PROOF OF EVIDENCE

Bangor Wharf, Georgiana Street, London, NW1 0QS

Appeal against London Borough of Camden's refusal of Planning Permission for the 'Demolition of all buildings on-site and new buildings of 1-6 storeys in height to include 46 residential (C3) units (18 x 1 bed, 19 x 2 bed and 9 x 3 bed) of which 30 would be market units and 16 affordable, new office (B1a) floorspace (604sqm) and associated works to highways and landscaping.'

COUNCIL REFERENCE: 2016/1117/P

Figure 1 Extract from Proposed First Floor Plan, Drawing no. 194/PL06/P2

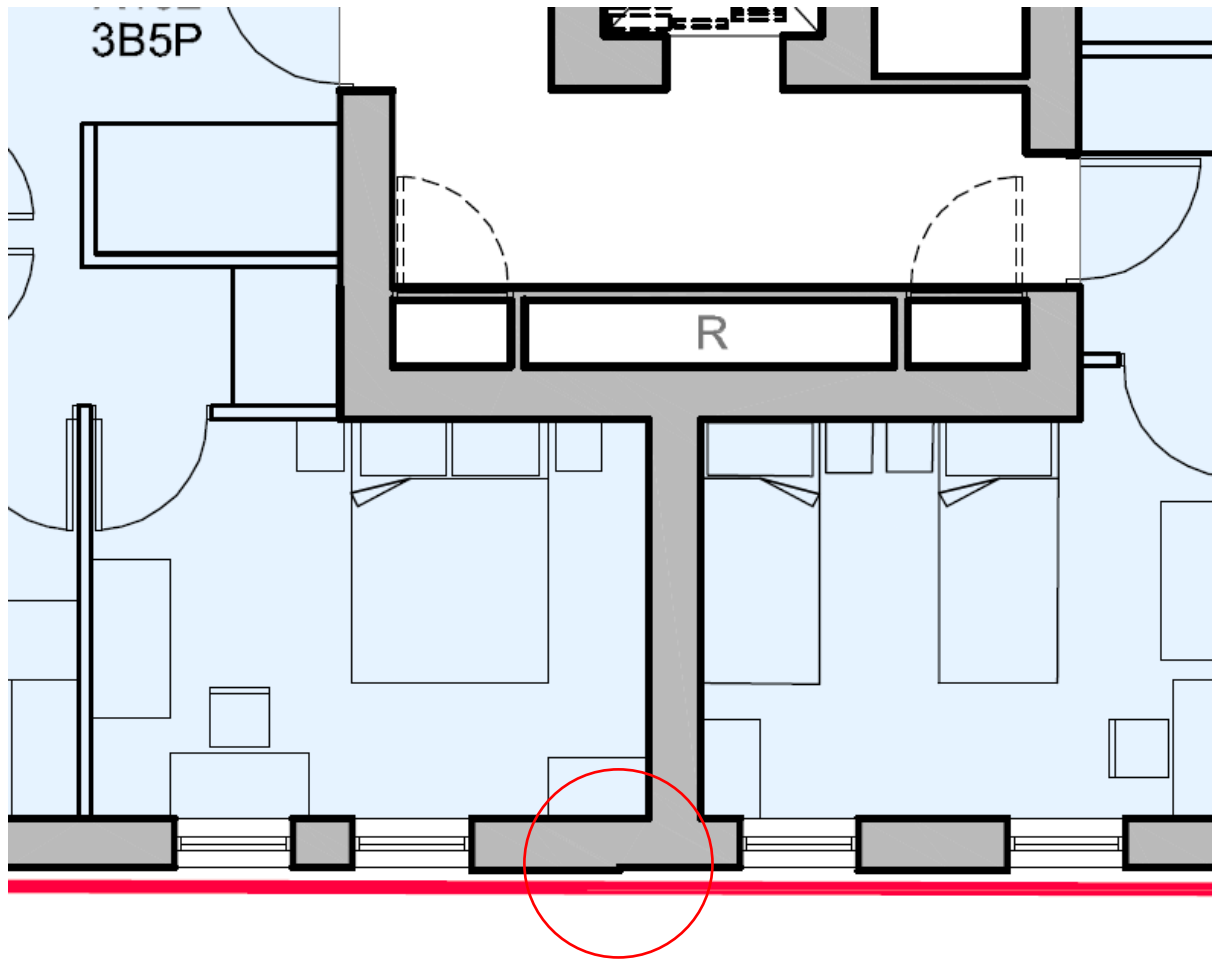
- 1.7 The façade features a series of pilasters spaced at irregular intervals relating to the pattern of openings at ground floor level. These are infilled by brick panels. Whilst the shadow shown on the elevation (drawing number 194/PL12/P3) indicates that there is a degree of relief to the pilasters, the plan exposes that the reveals are so shallow as to be almost imperceptible (see Figure 1 below, extract from Proposed First Floor Plan, Drawing no. 194/PL06/P2). The narrow proportions of the window openings and large areas of blank brickwork further contributes to the flatness of the façade.
